City of Tarpon Springs, Florida

Heritage Preservation Board

REGULAR SESSION AGENDA MONDAY, MARCH 3, 2025 6:30 PM - CITY HALL AUDITORIUM

STAFF REPORT
February 21, 2025

PROPOSED PROJECT

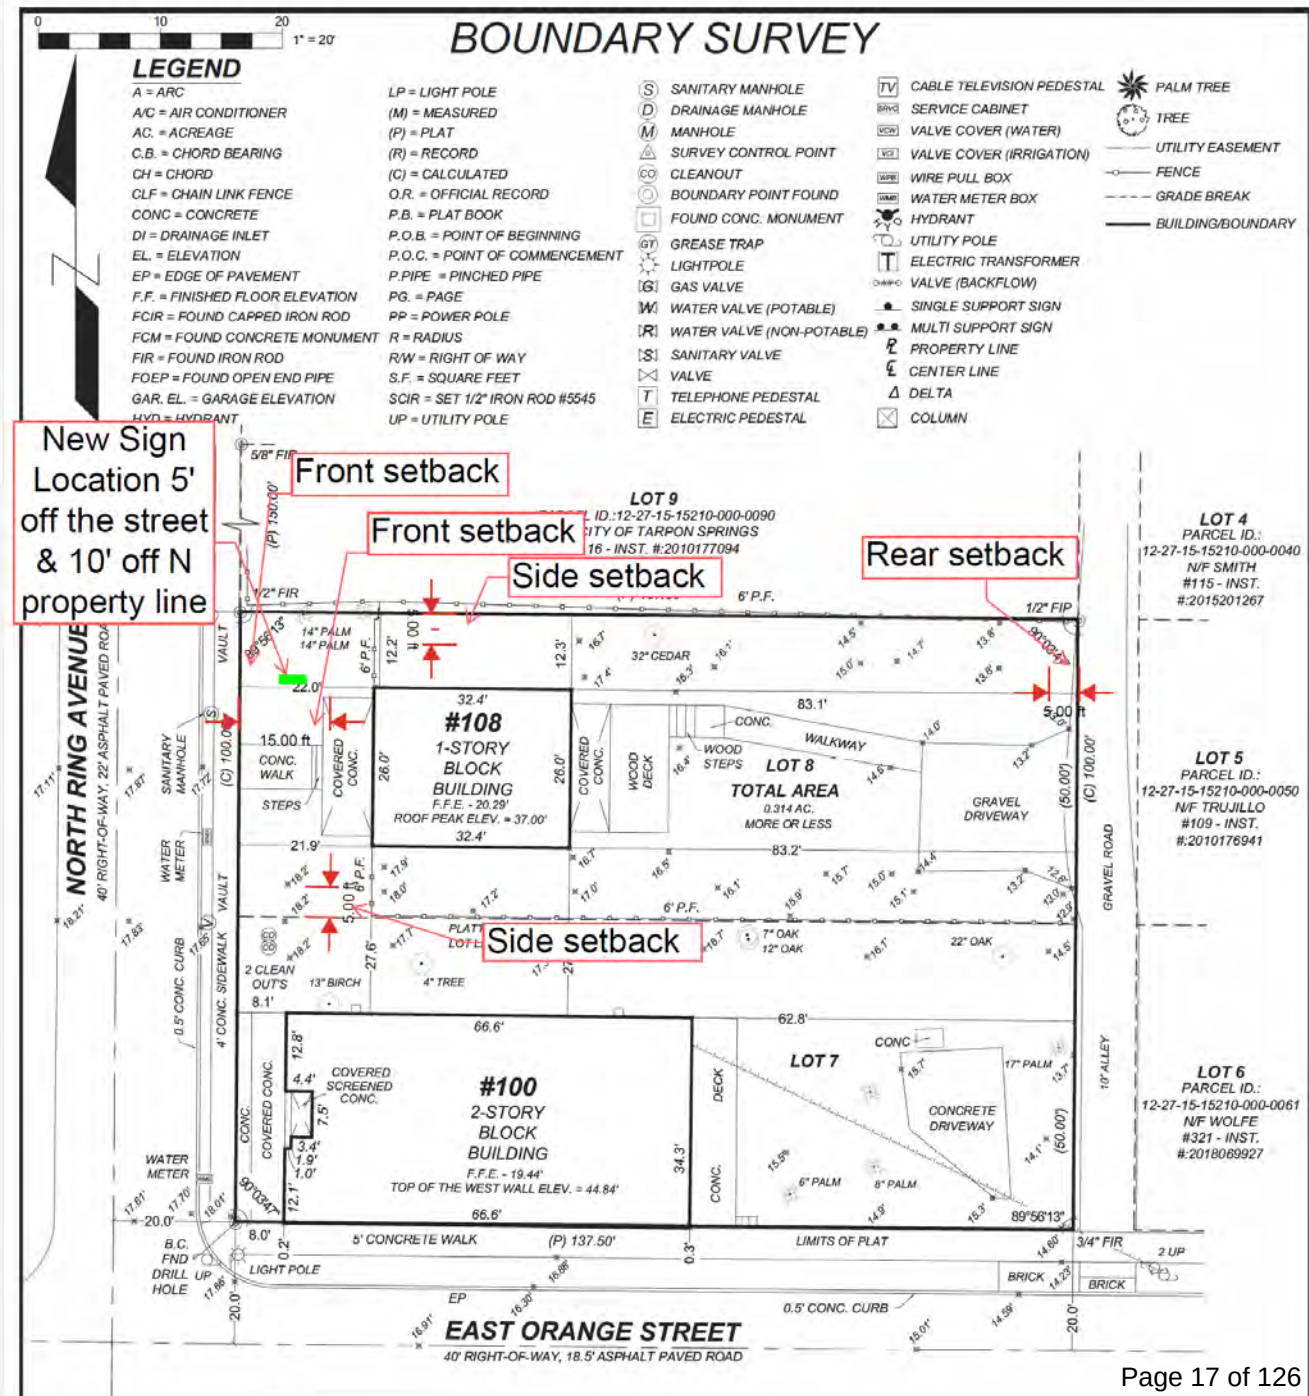
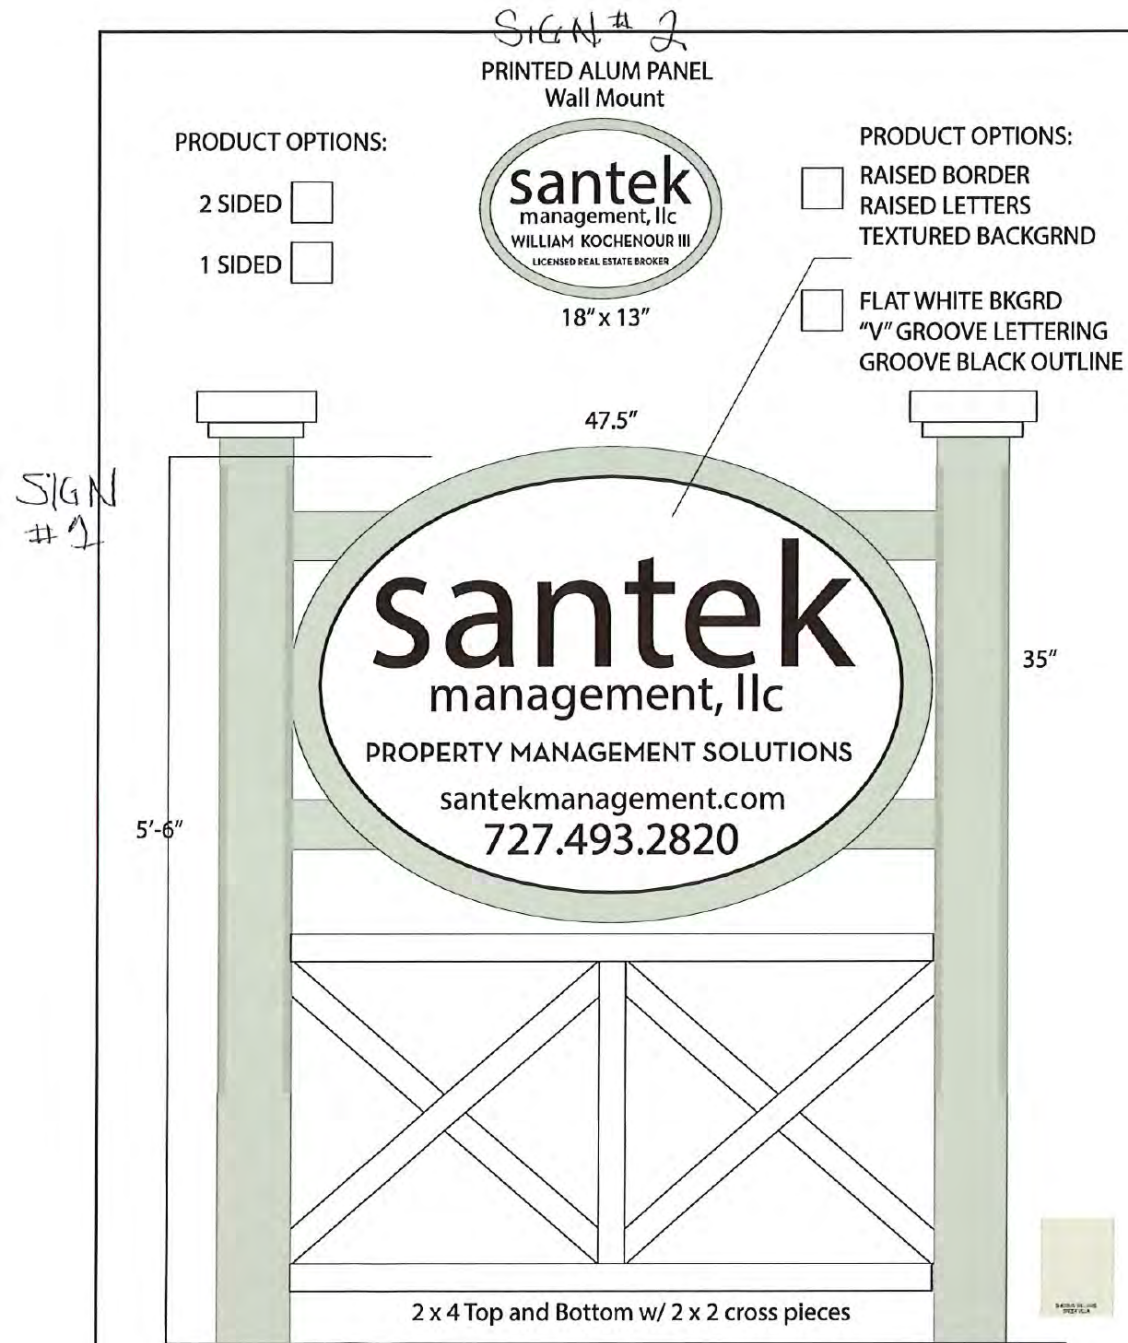
ANALYSIS: The height and width of the proposed new freestanding sign is consistent with signs at structures of similar character in the vicinity. The freestanding sign at 18 N Ring Avenue, a contributing structure, has similar dimensions as the proposed free-standing sign. The proposed wall sign is smaller than the wall signs at neighboring properties, presenting less of a visual impact.

ANALYSIS: The addition of the proposed signs will slightly alter the streetscape. The proposed project conforms with setback requirements. The free-standing sign is designed to relate architecturally to the subject structure through the repetition of the cross motif present on the porch railings. Although the streetscape will be altered, it is staff's opinion that the repetition of the cross motif from the porch, and the placement of the sign on the north edge of the property would have a beneficial impact to the rhythm of the streetscape. The HPB should satisfy themselves that the impacts to the streetscape are not significantly adverse.

ANALYSIS: The mass of the structure will be minimally altered on the western elevation by the proposed protruding wall sign. The HPB should satisfy themselves this visual alteration is not adverse.

The proposed project meets the intent of the Secretary's standards, as no historic materials will be removed. The proposed new sign will alter the viewshed but is consistent with signs in the vicinity and will have no irreversible impact.

Staff recommends **approval** of the project as presented by the applicant based on the review criteria as described in this staff report, with the following condition:

219 Grand Blvd/Gallagher Residence
Existing unsympathetic windows

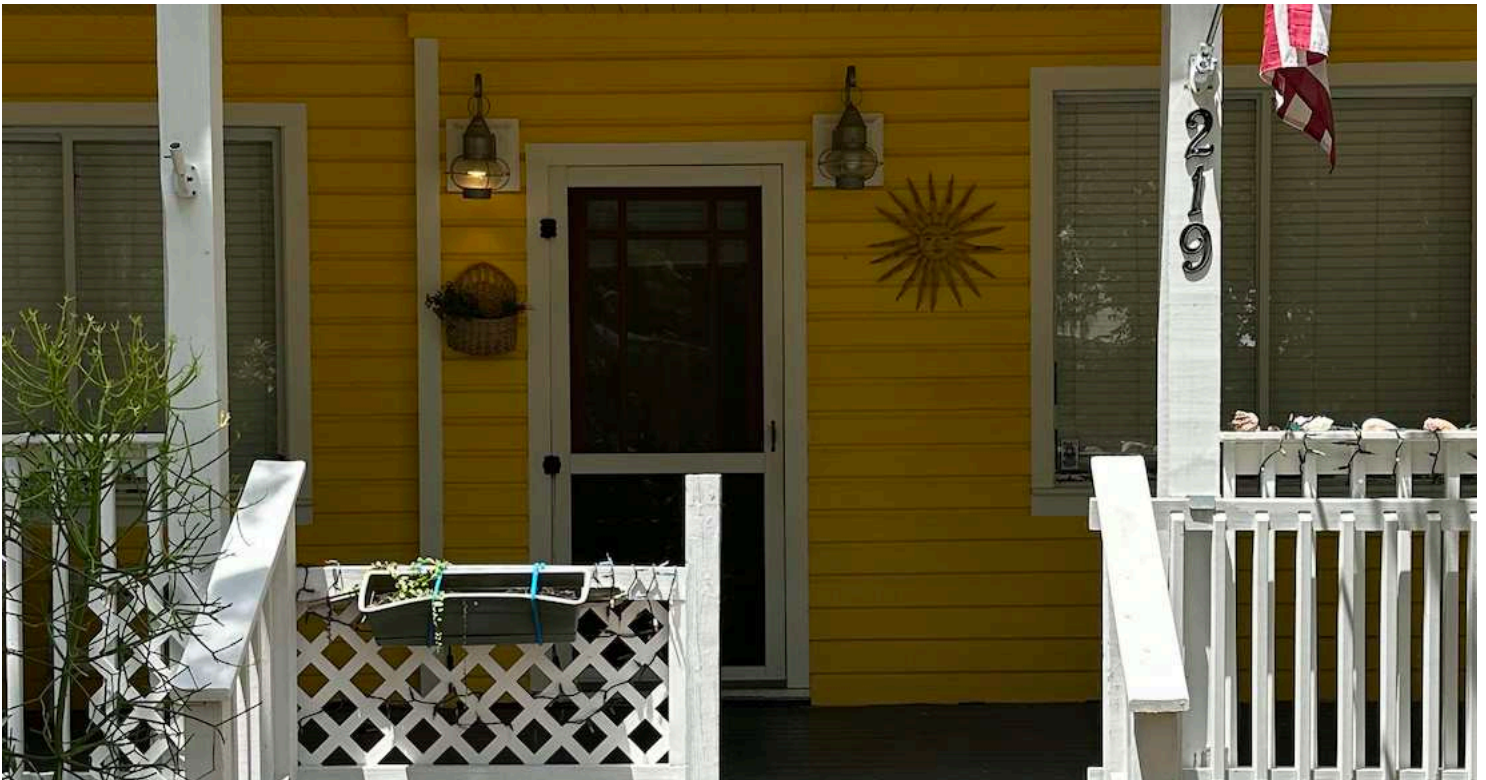
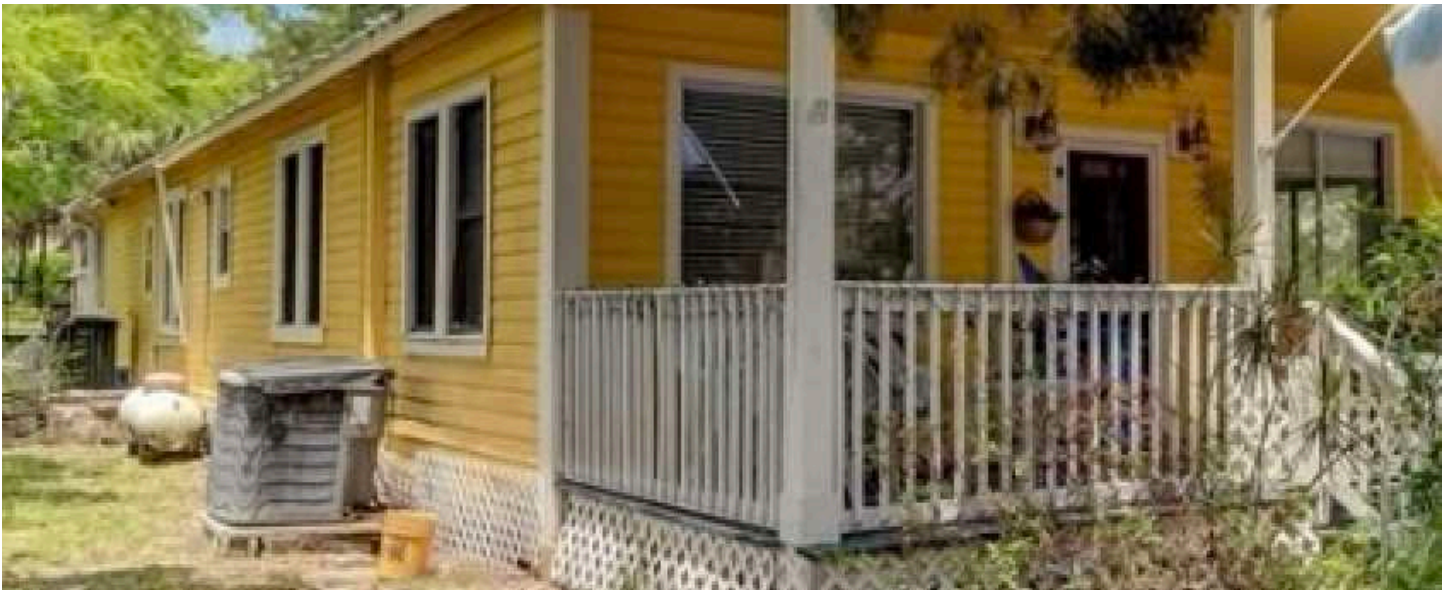
ANALYSIS OF WINDOW REPLACEMENT: The proposed project would replace non-original windows with composite windows on facade and vinyl windows on the remaining elevations. The DGRM states that: "Vinyl or vinyl clad windows are acceptable replacements only on mid-20th century properties, on non-visible elevations, and on non-contributing properties." The applicant is proposing the use of composite windows on the façade, the most prominent elevation on the structure. Composite windows more closely replicate the appearance and texture of wood windows than vinyl.
